**ADDENDUM  
NO. 3**

**Carmel High School 2026 Improvements Projects  
520 E. Main Street  
Carmel, IN 46032**

2026 Carmel High School – Improvement Projects

Addendum No. 3, 6 items, 2 pages  
New Project Manual Section: 26 36 00 – Transfer Switches  
Revised Drawing Sheets: E-001, EL101, ES101, E-601, and E-602

# Project Phasing Schedule

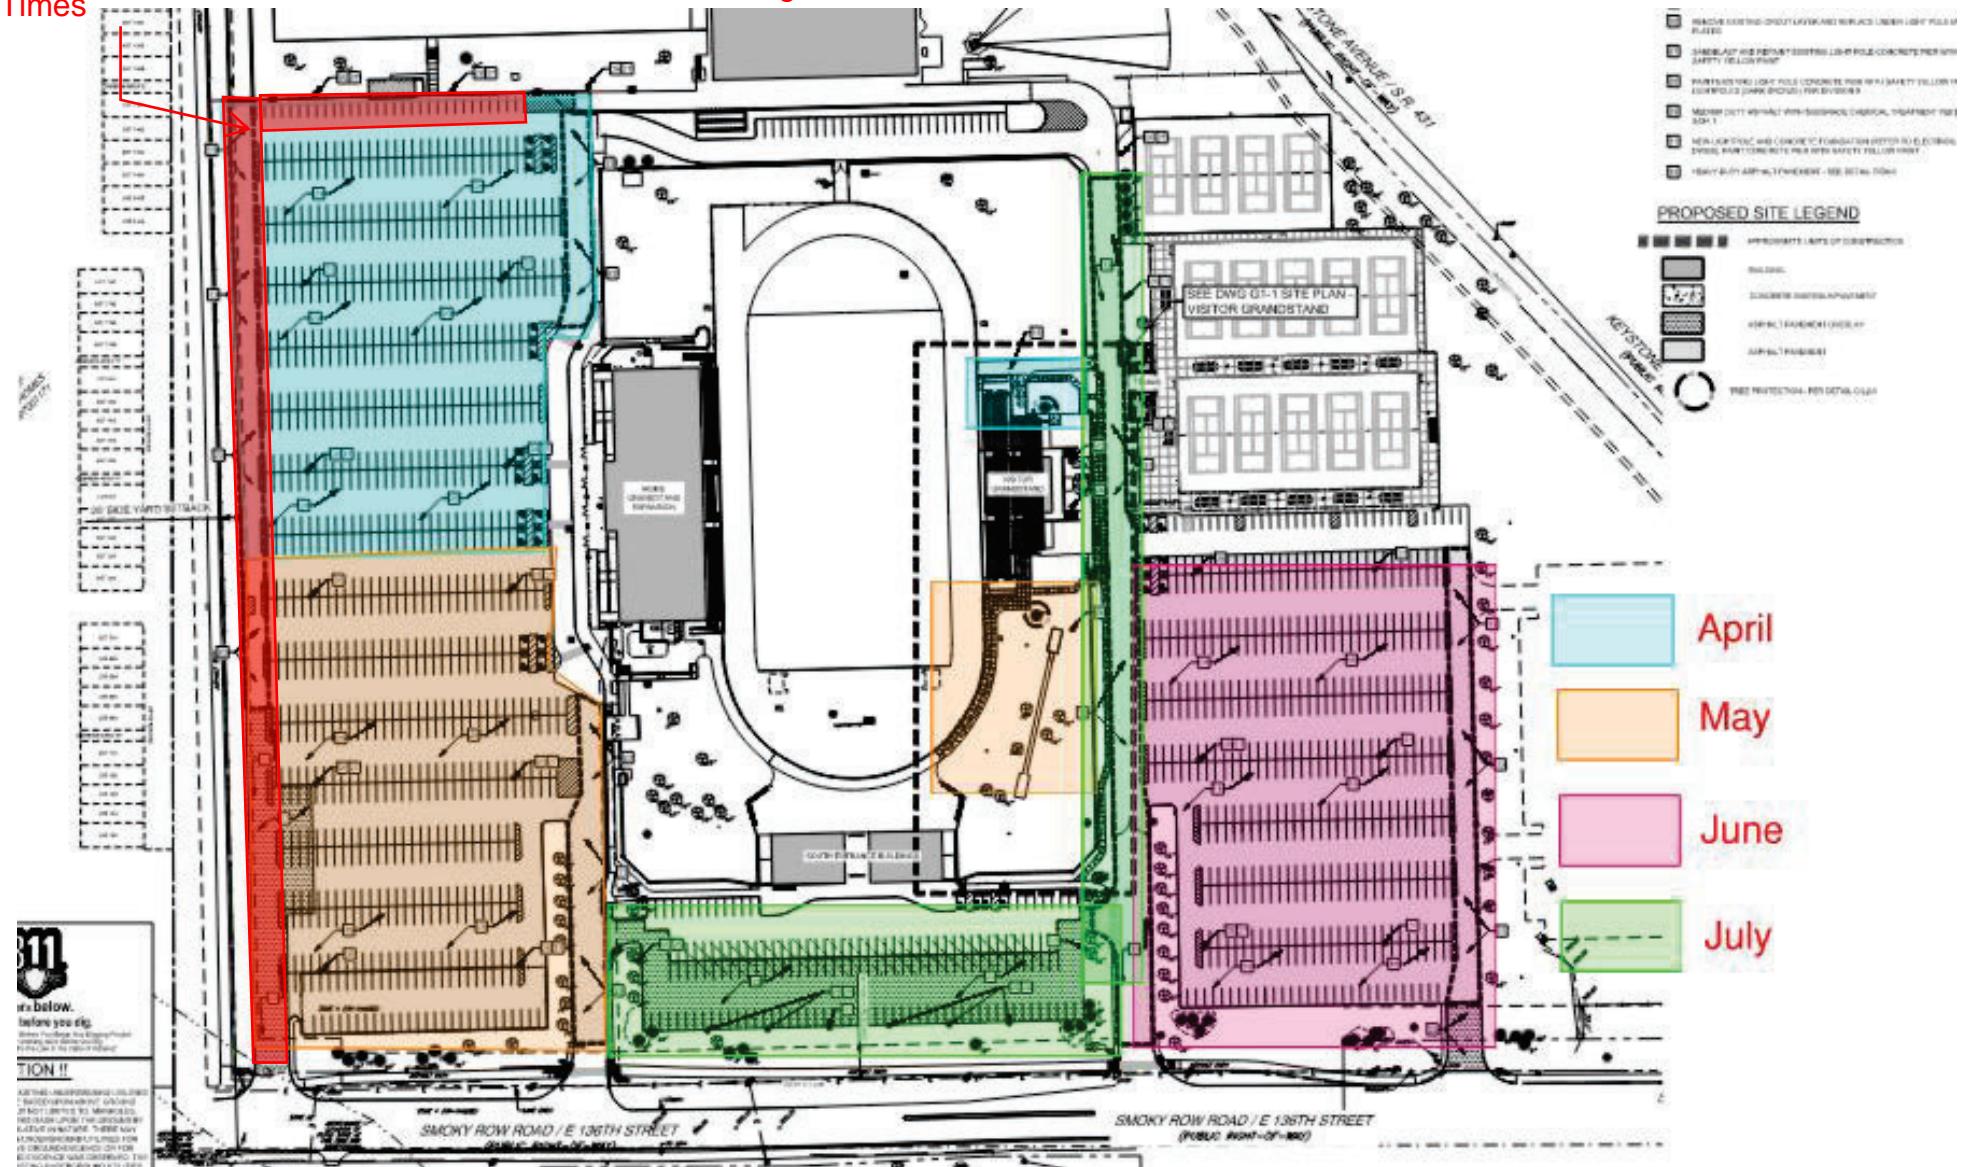
Insert 01 32 00 Paving Phasing Plan

Access to be maintained to North Lot Practice Fields at All Times

Late April - Follows completion of Blue Prior to Orange

# FRESHMAN CENTER GENERATOR ONE-LINE DIAGRAMS

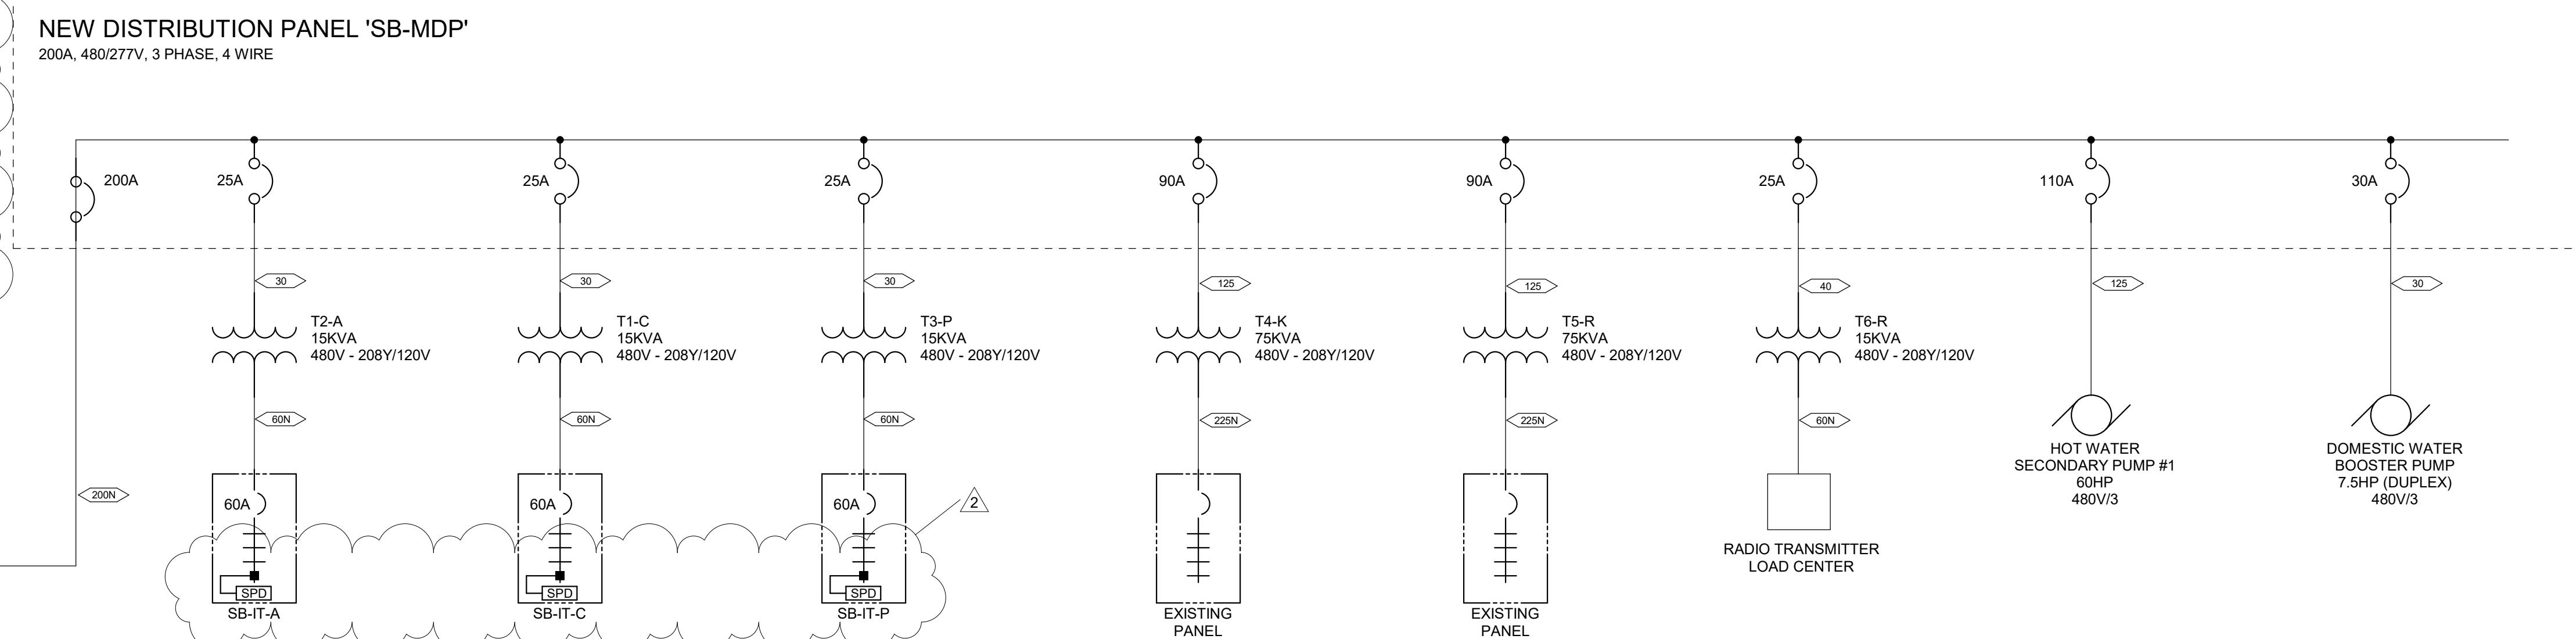
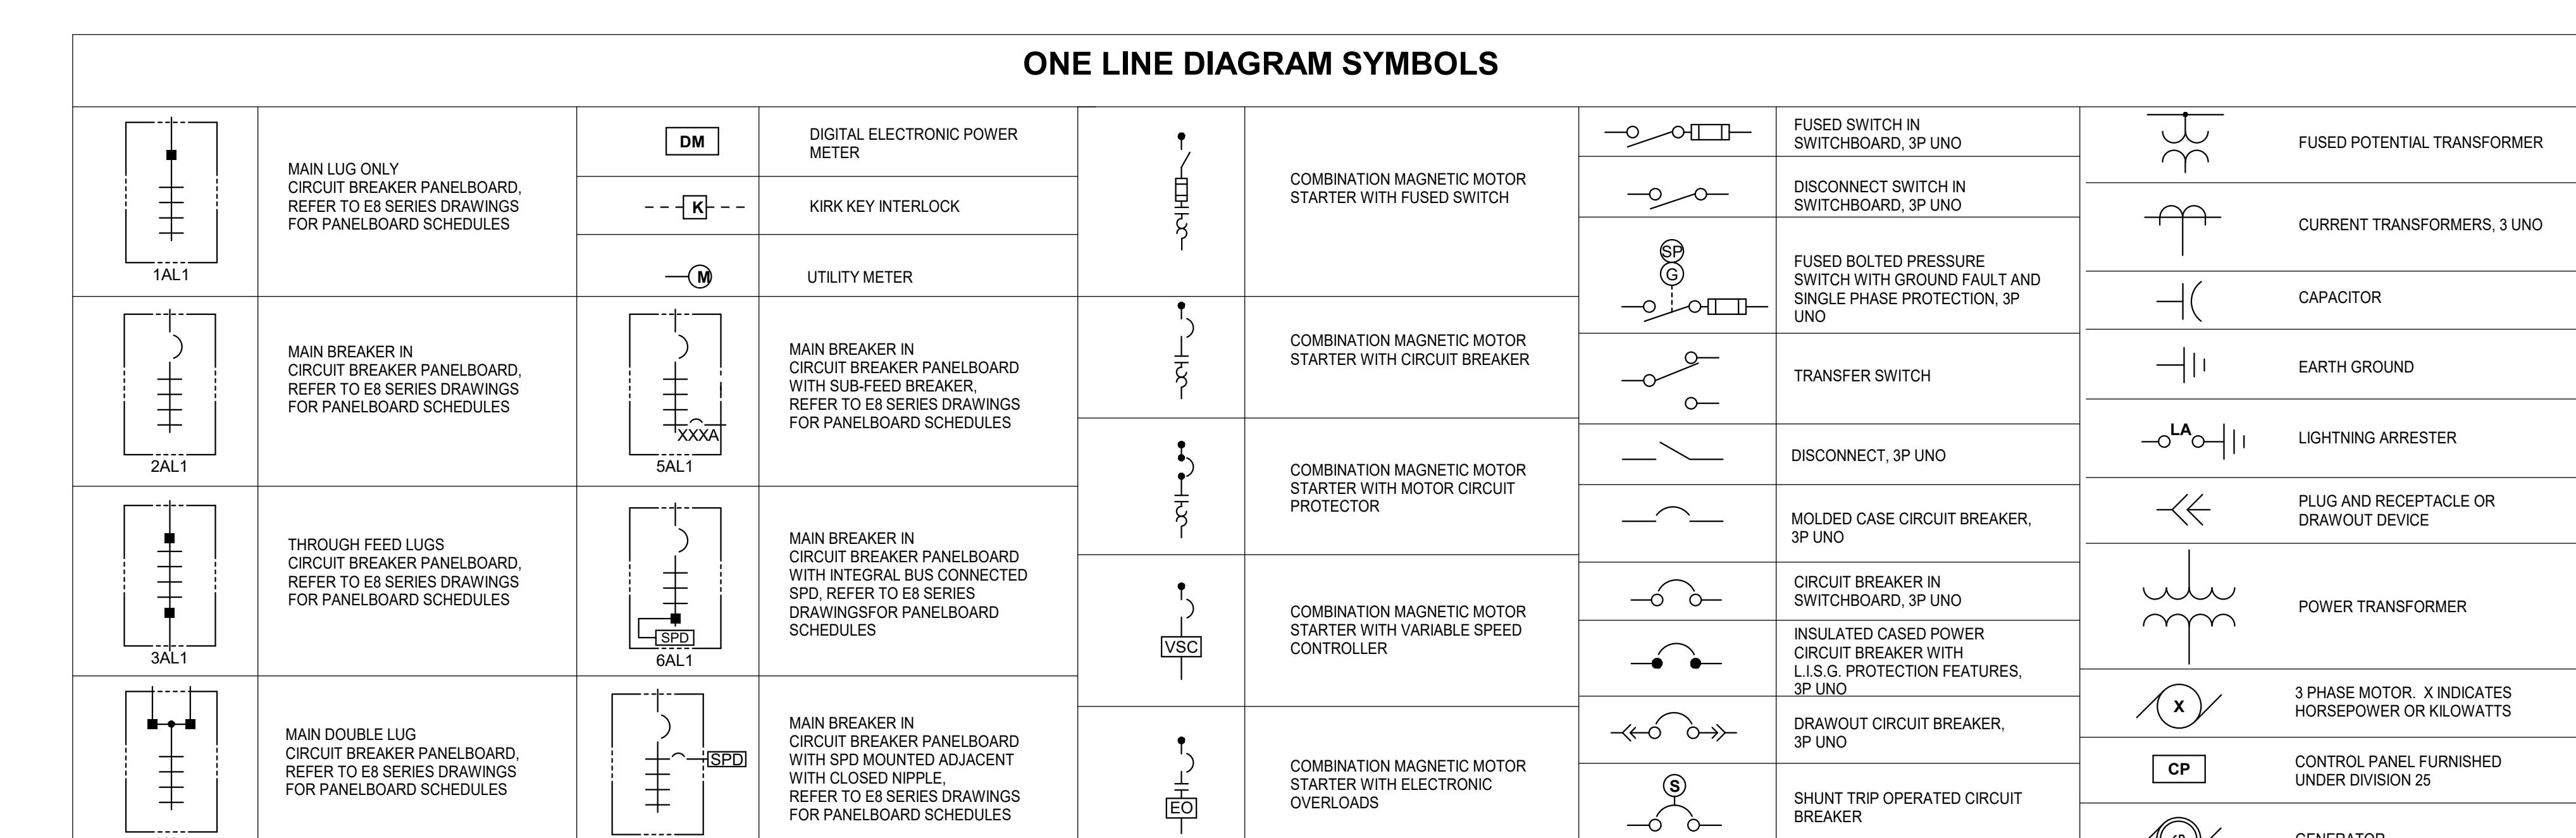
EXISTING GENERATOR IN ROOM XXX

EXISTING xxxA/3P

TO EXISTING SWITCHBOARD

NEW SB-ATS

## **ELECTRICAL SITE PLAN**

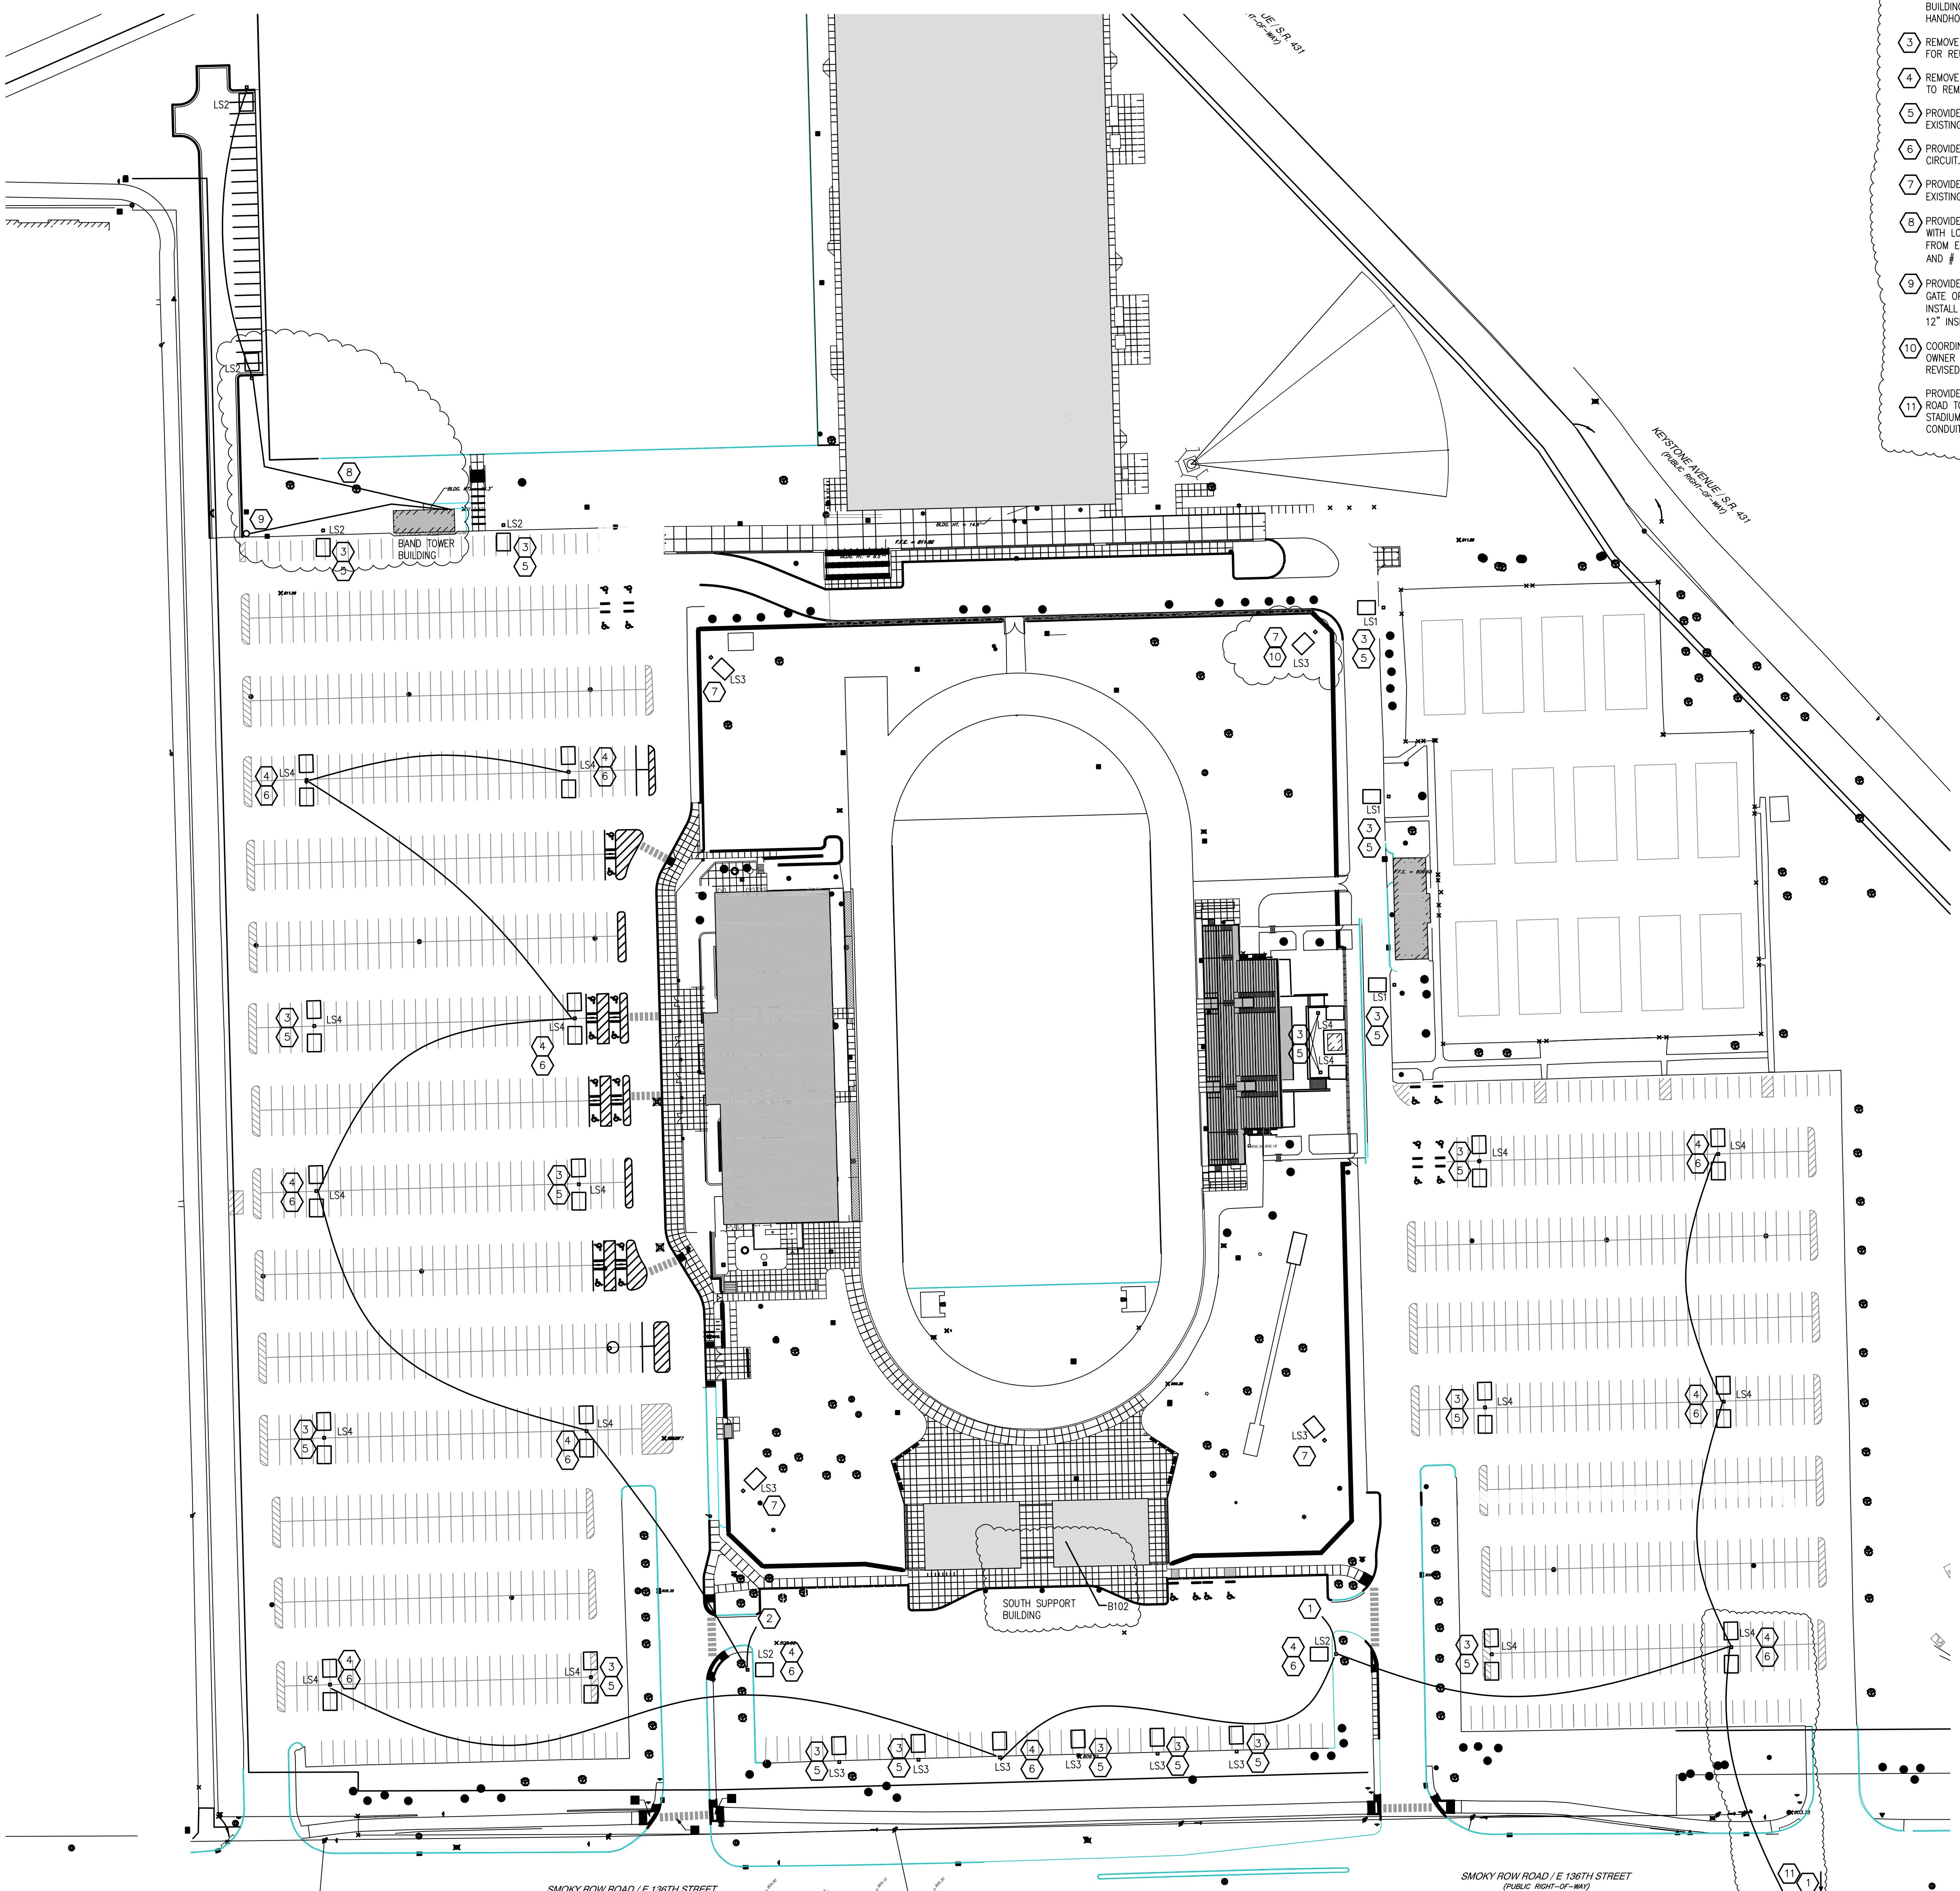
- 10. COORDINATE THE EXACT LOCATION OF THE NEW LIGHT POLE WITH OWNER BEFORE ROUGH-IN TO ADJUST AS NECESSARY FOR SHOT PUT REVISED LAYOUT.
- 11. PROVIDE HDPE CONDUIT DIRECTIONALLY BORED UNDER SIDEWALKS AND ROAD TO NORTHERNMOST EXISTING PEDESTRIAN LIGHT POLE ALONG STADIUM DRIVE FOR CAMERA POWER. FOLLOW PATH OF TECHNOLOGY CONDUIT.
